Job Title	2-G BEACH RD, CATTLEHAMPTON	Item	REARRANGEMENT
Designed by		Date	
Checked by		Job No.	50606
		Sheet	10
		Rev

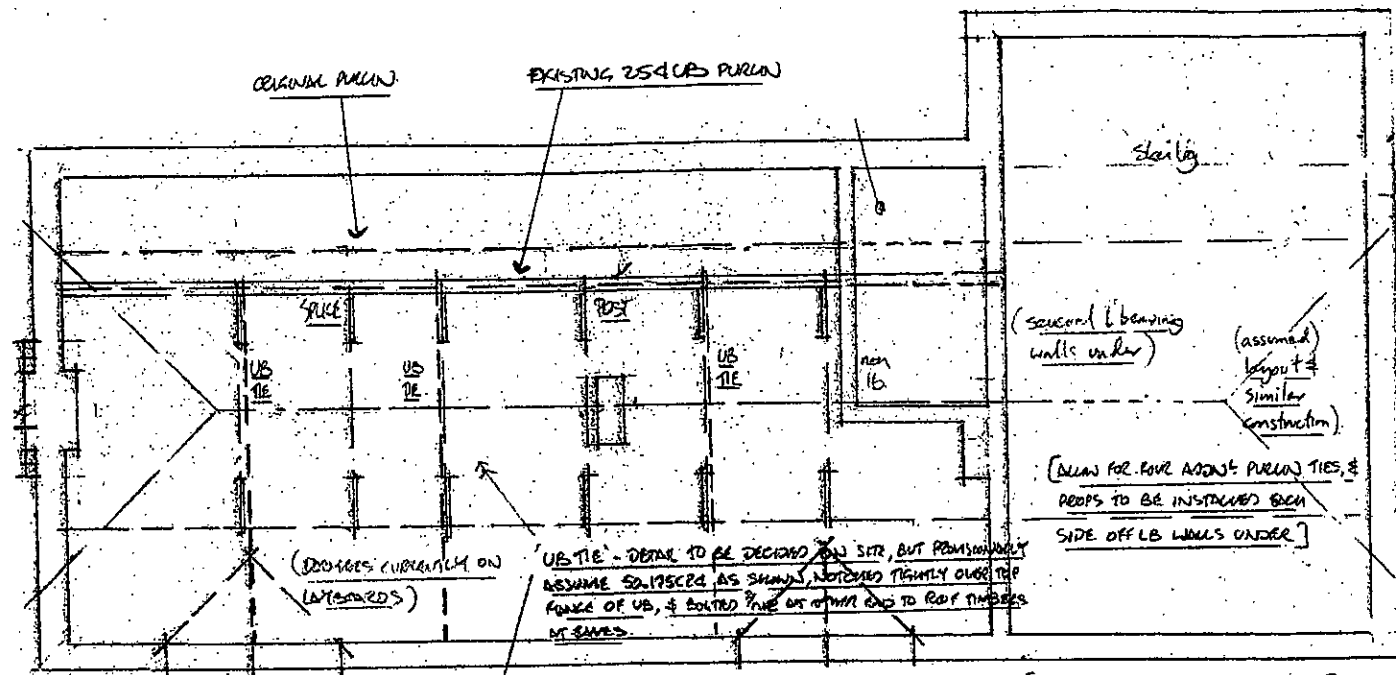
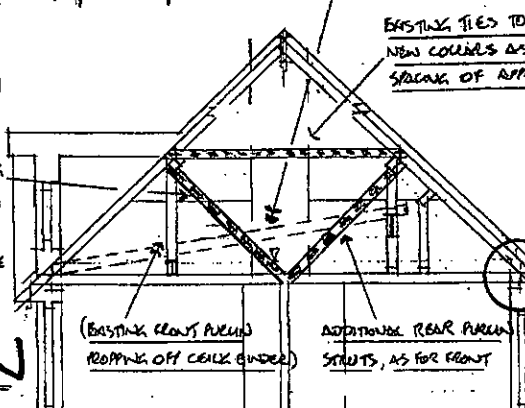
FRONT PURLIN PROPPING TO BE IMPROVED WITH DIAGONAL BRACING (SC-75CE2A) AT 1000% APPROX.

REAR RAFTER FOOT ALONG WEST WALL MUST BE PROPERLY TIED IN TO CEILING COUPLERS. IF POSSIBLE THE RAFTER LINE IS TO BE STRENGTHENED AND DROPPED BACK ONTO THE RAFTS - BUT THE VERTICAL AND HORIZONTAL SUPPORTS MUST BE SECURED WITH RATCHING AND STRAPS / SPACE JOISTS TO BCO / BAK. APPROX. (USE M10 M12 BOLTS FOR FIXINGS, WITH DOUBLE BOLTS AT SPACE LAPS)

DETAILS ASSUME THAT TILES & BATTENS ARE REMOVED FOR ACCESS
